THE BOND (fka The District) JSP18-10

Consideration at the request of Bond at Novi LLC for JSP 18-10 for recommendation to the City Council for approval or denial of the revised Preliminary Site Plan and Storm Water Management Plan. The subject property is zoned TC-1 (Town Center One) and is approximately 7.74 acres. It is located west side of the recently renamed Bond Street in the south west corner of Grand River Avenue and Novi Road in Section 22. The applicant previously received approval of the proposal of a mixed-use development with two four-story multi-family residential buildings with a total of 260 apartments and a single-story commercial building (5,578 SF). The current submittal makes revisions that will require modifications of some of the previously approved waivers.

PLAN REVIEW CENTER REPORT

2nd Revised Preliminary Site Plan

SHEET NUMBER
L4.04

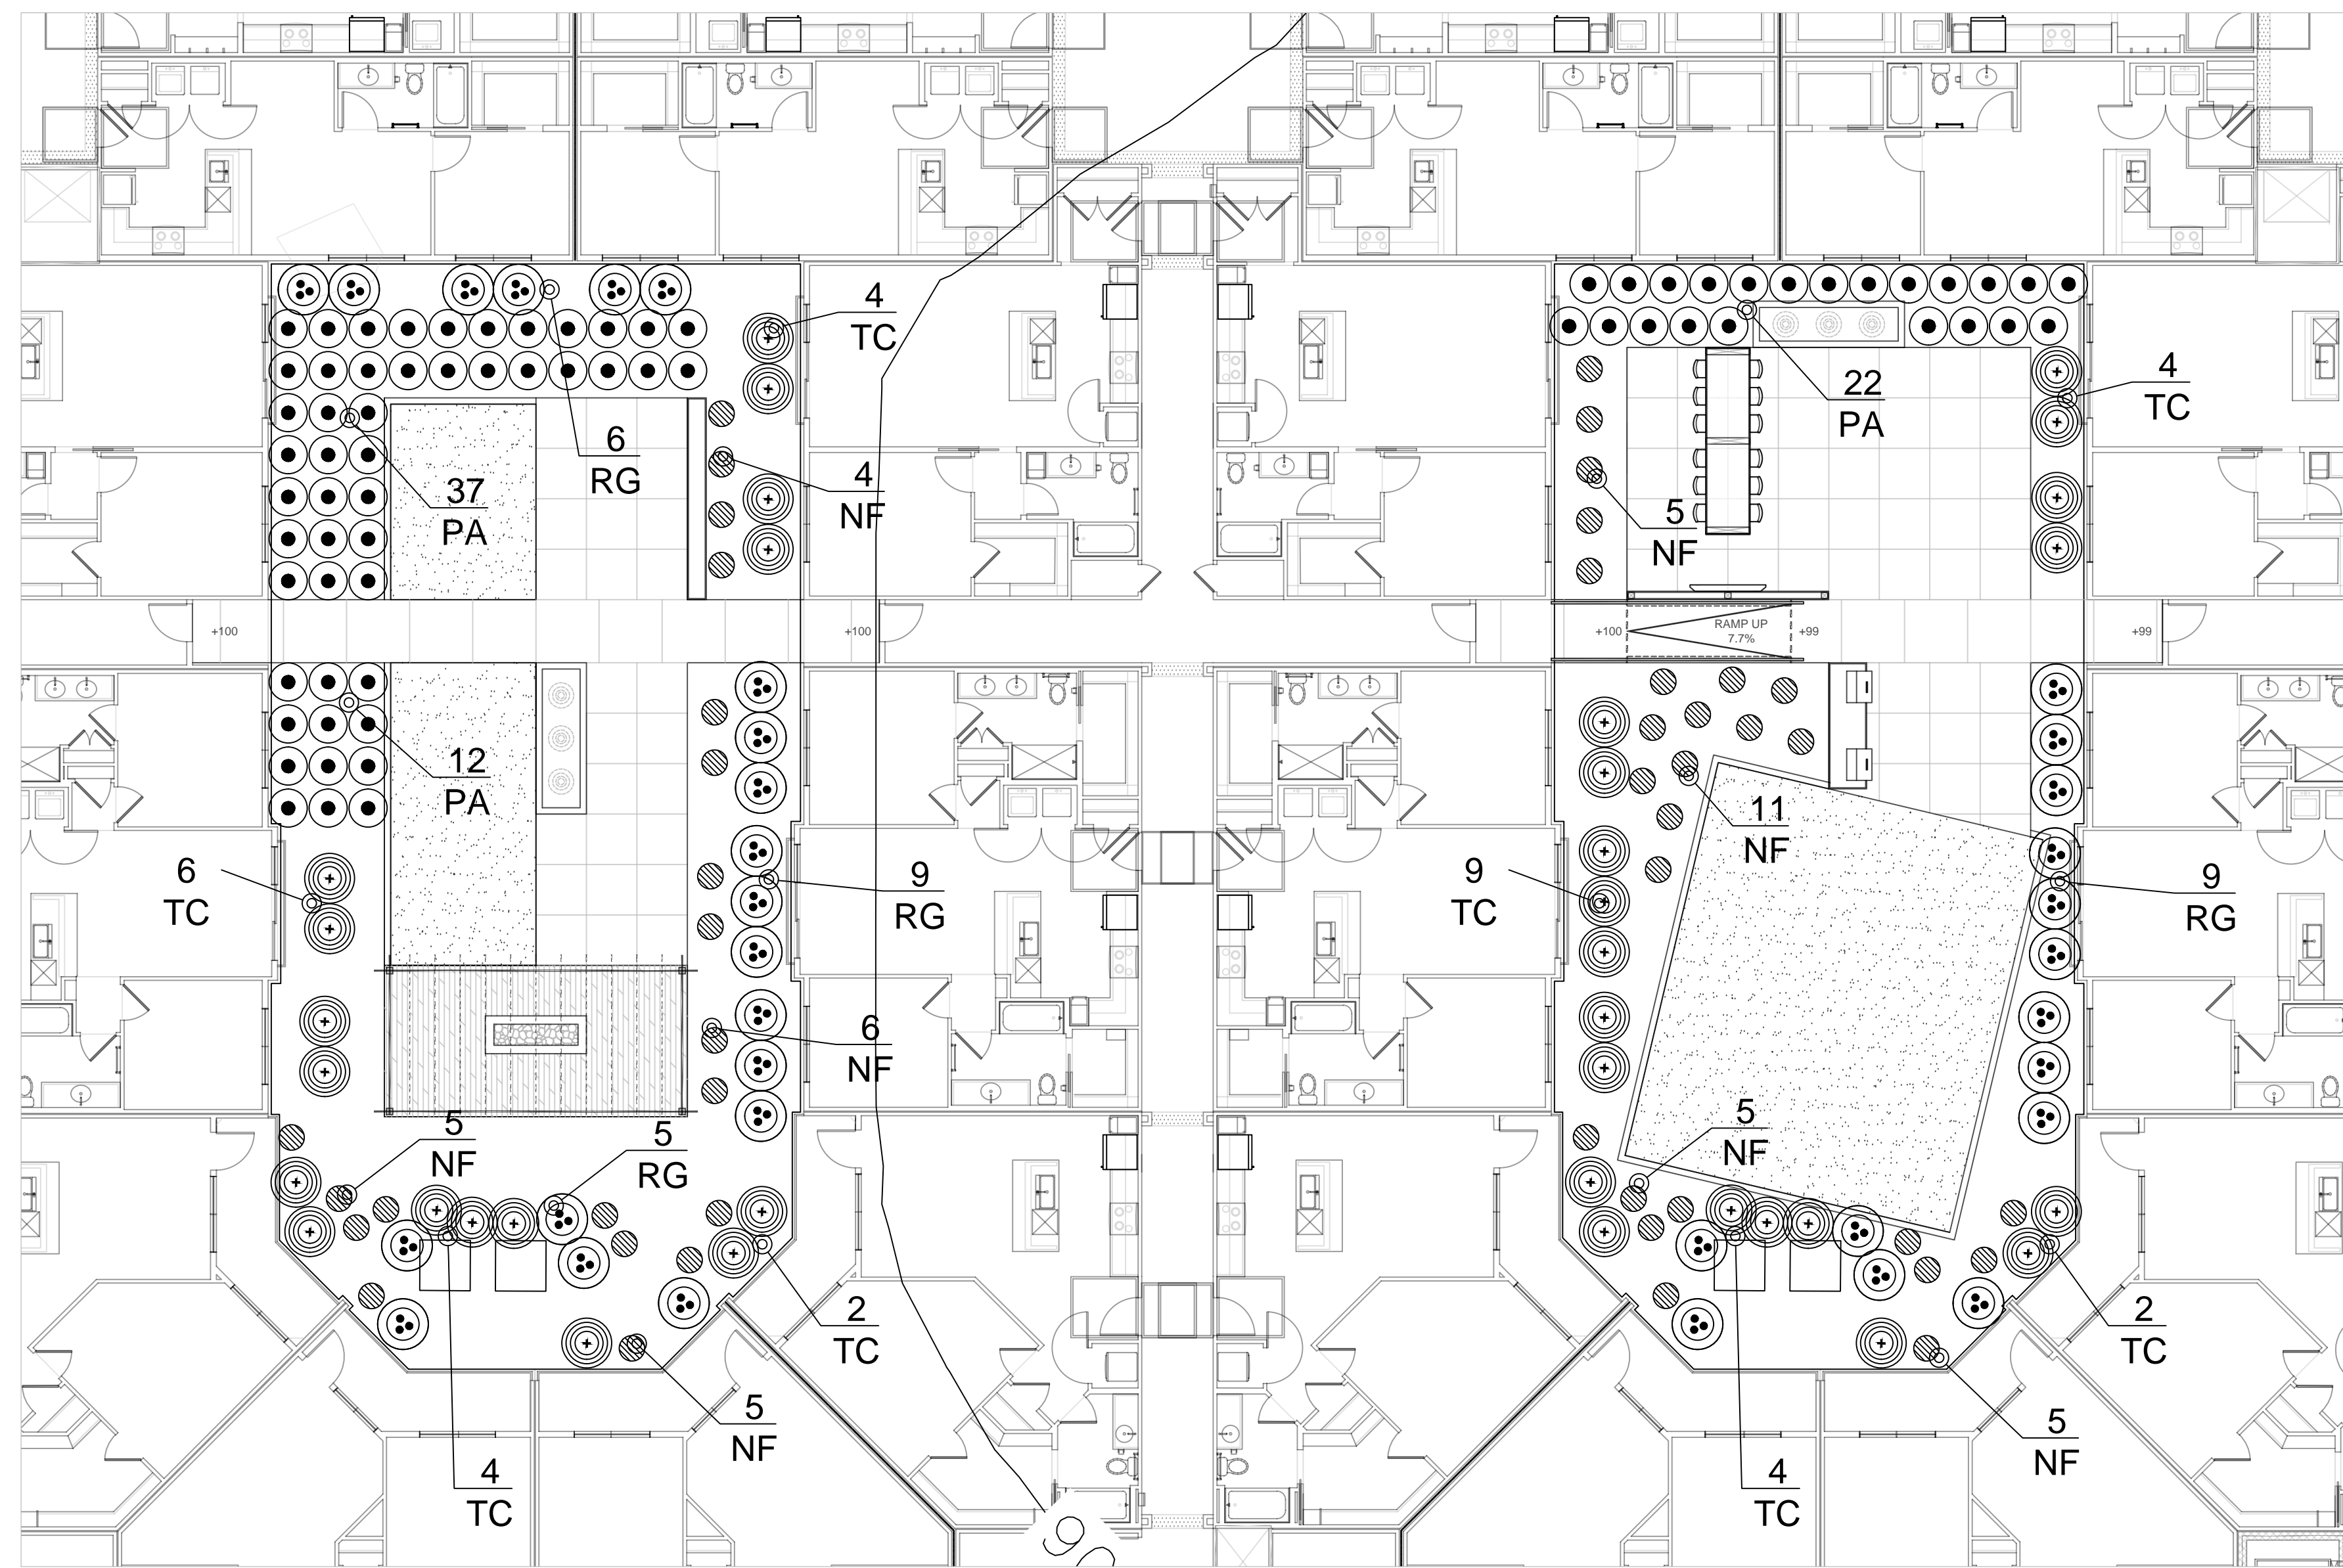
<p>Foundation Landscaping</p>	<p>35% of building façade fronts in multi-family section should be landscaped</p>	<p>All frontages exceed the 35% minimum landscaping requirement.</p>	<p>Yes</p>	<ol style="list-style-type: none"> 1. Please use a larger plant than <u>Pennisetum alopecuroides 'Hameln'</u> along the north side of Building 2. Straight <u>Pennisetum alopecuroides</u> would be acceptable. 2. Please label courtyards per their Building number, not East or West, on Sheet L4.04, as it appears they are shown per building.
